### 2 Type of change

- Rating for VDE and CCC according IEC 60320-1
- Rating for UL new 15A for all variants

Product Change Notification					PCN DC11		
owner	creation date	release date	released by	change order no	rev	page	D10-041-422
huberth	03.12.2019	20.12.2019	muehlema	2018891	A	1 of 2

Old product approval and rating	New product approval and rating

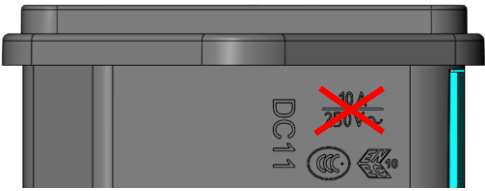
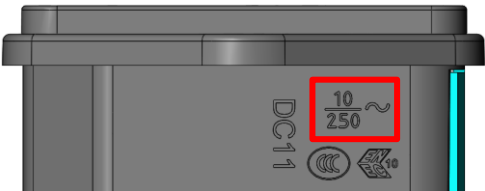
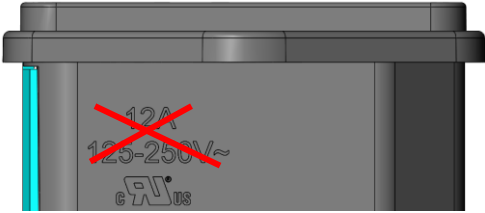
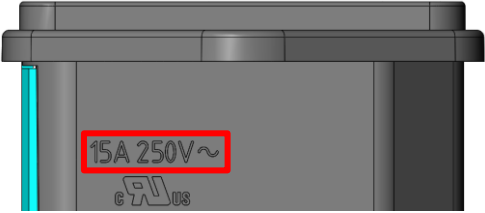
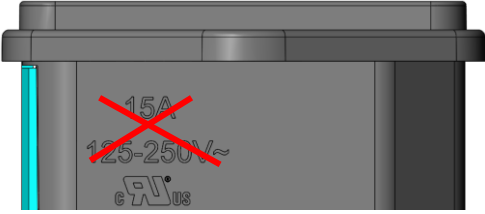
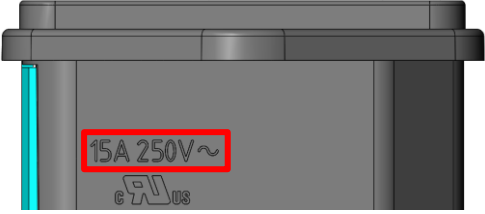
old 12A-Variants	new valid up to 15A

15A-Variants
